Product Change Notice: Changes on label marking of NMP Series

Date : 2021/01/26

Due to product launch of dual output module card, NMD-240, changes will be made to both label markings in print and DBANMP1K2 and DBANMP650 model labels that are attached on NMP1K2/650 front-ends. Changes will be implemented in two phases:

Label markings in print

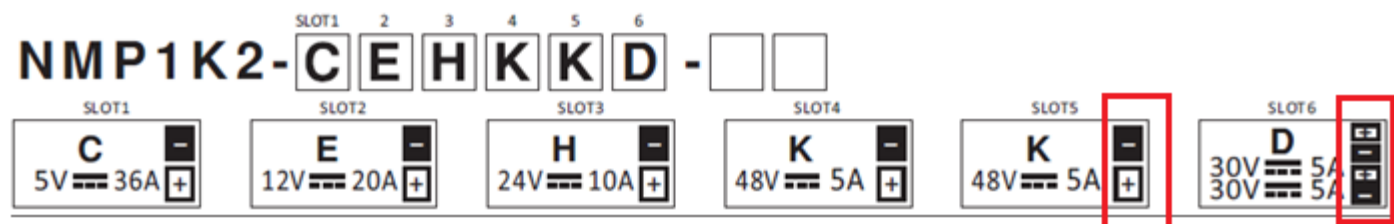
1. Phase 1, label markings in print add +, - symbols and color blocks to the right side in each bracket, from SLOT 1 to 4/6.
2. Phase 2, model labels add diagram pertaining to dual output module, indicating signal connector **CN82** and tuning direction while using SVRs to adjust output voltage of +V1/+V2.

Before

After : add +, - symbols and color blocks to the right side in each bracket
